From: Sent: To: Cc: Subject: Attachments: Junwei Ang Thursday, 11 March 2021 11:42 AM Ram Ramachandran Jeffrey J Weeks; Imtiaz M Abdul; Bernard W Tham; Peri Konesh Design and construction signalised crossings at Webster Road, Aspley 10032021175746-0001.pdf

Page Number: 2 of 333

BRISBANE CITY COUNCIL GYMPIE ARTERIAL ROAD (U14) WEBSTER ROAD SLIP LANES UPGRADE

NORTH BRISBANE BIKEWAY - CHERMSIDE TO ASPLEY WEBSTER ROAD TO NEVIN STREET, ASPLEY - STAGE 1

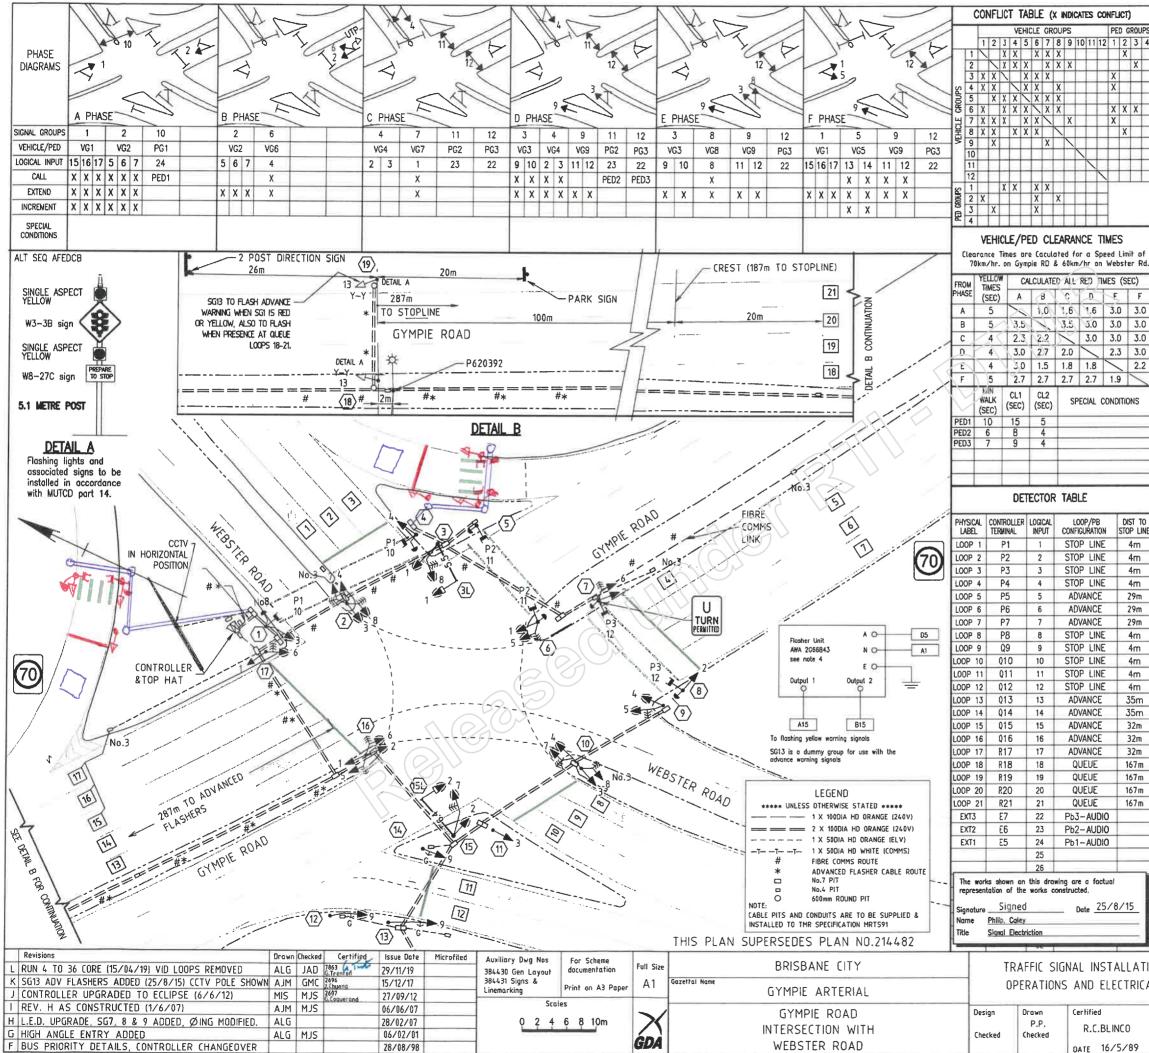
I have requested BCC provide us their latest plans to show all works in that area but for now, can you use the attached annotated plan from DRD to progress the high level cost estimate. For this current exercise, please assume minimal works by BCC other than to widen the existing ped path to a 3m wide shared path which we would connect into on the N/E quadrant and for us to connect to existing on the S/E quadrant. Please provide the high level estimate asap so we can formalise the funding arrangement for design and construction with DRD and RD.

RL-1 of 2

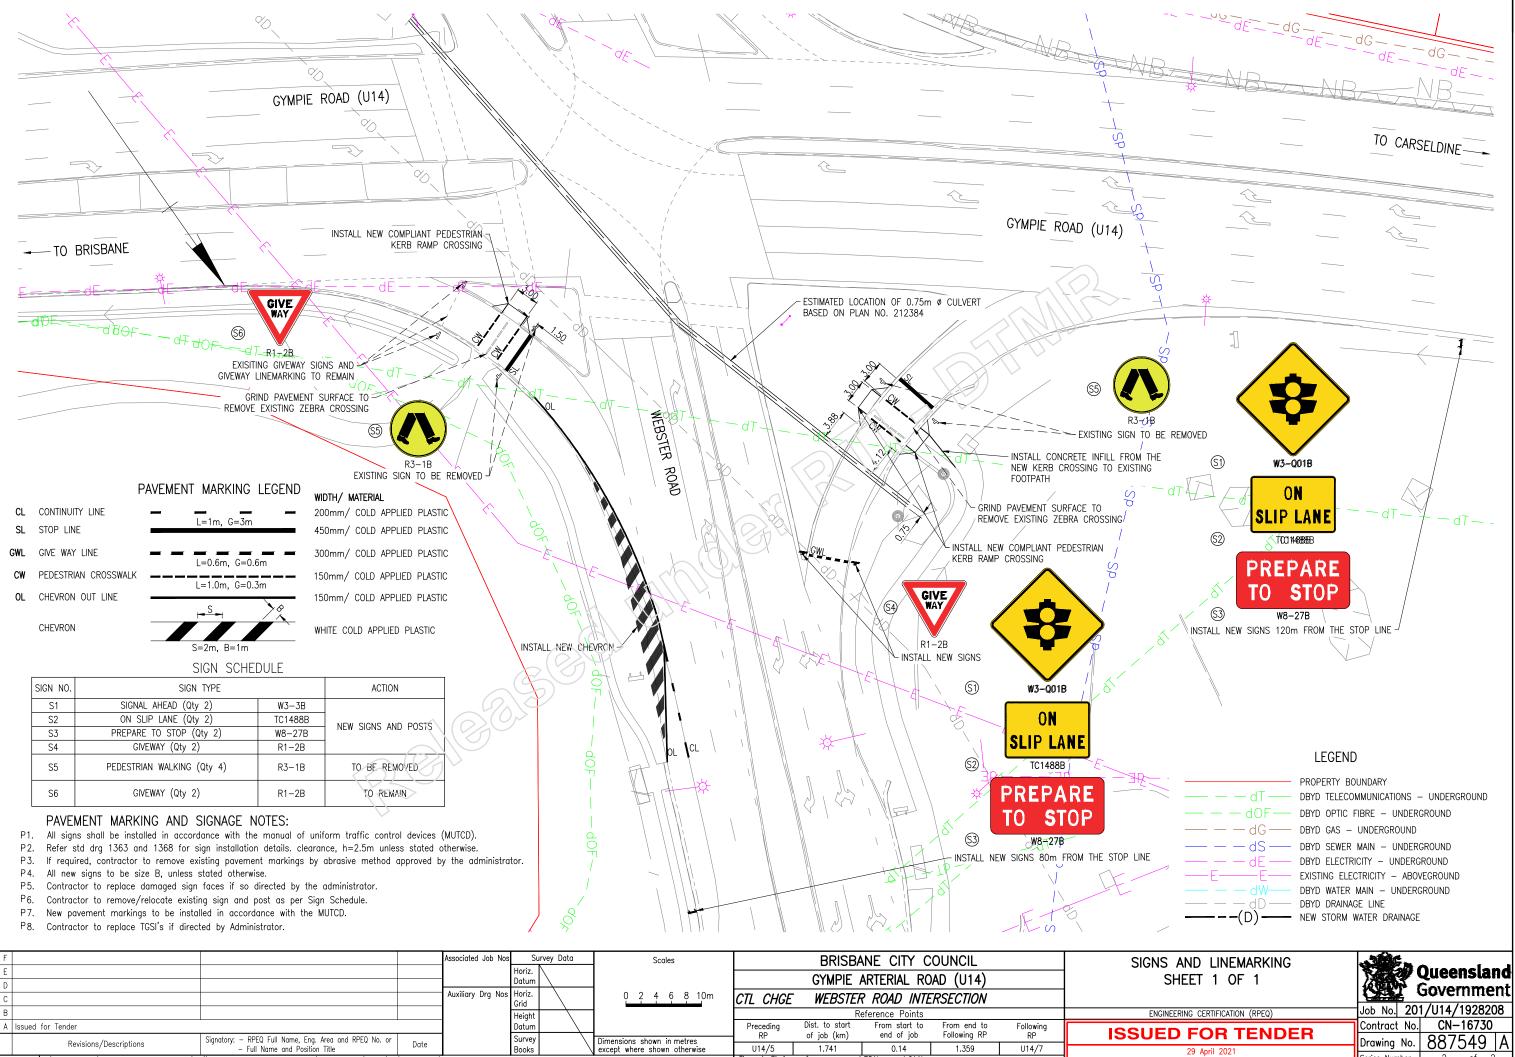
Drawing 887554: Could we please reduce the new conduit that we running from Pole 45491 (currently shown as New 2x100mm UPVC Conduit) to one (New 1x100mm UPVC Conduit) instead of two? Is there a reason on why we have 2x100mm?

• Revise the pole number from PP34689 to 45491 (Drawing 887554). Please see below photo of the location and photo taken today:
